## Arboriculture

Thank you for consulting on this EIA Scoping Opinion.

Contemporary map showing arial view with the height bands of trees and hedges on site:

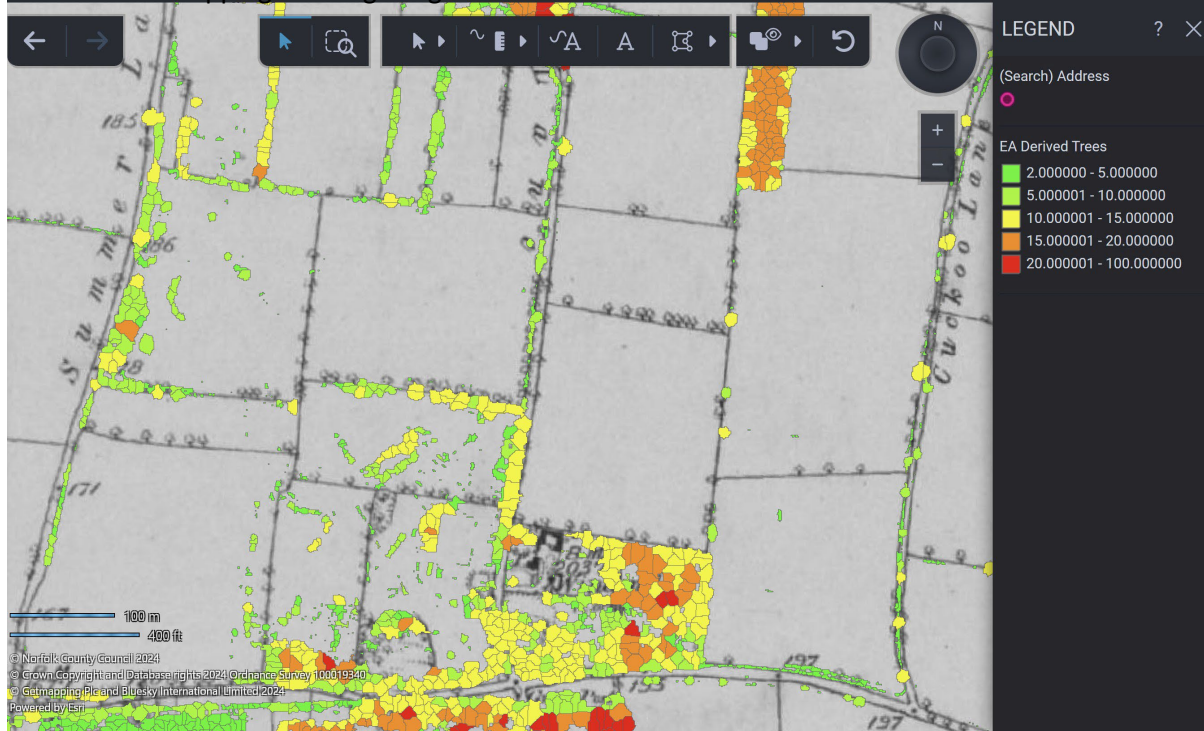
There are field boundary trees that are within the proposed area of works. These trees are in the same location as trees marked on the 1<sup>st</sup> edition OS map dating from around 1880 and it is likely that the trees are at least 150 years old, and likely to be significantly older. The potential age of these trees raises the likelihood that there are ancient or veteran trees which receive greater protection under section 186c of the NPPF. An assessment must be made as to whether these trees are ancient / veteran and if they host any protected species.

The outline proposals will impact on existing trees and a full arboricultural impact assessment and method statement in line with BS 5837 (2012) – Trees in Relation to Design, Demolition and Construction will be required.
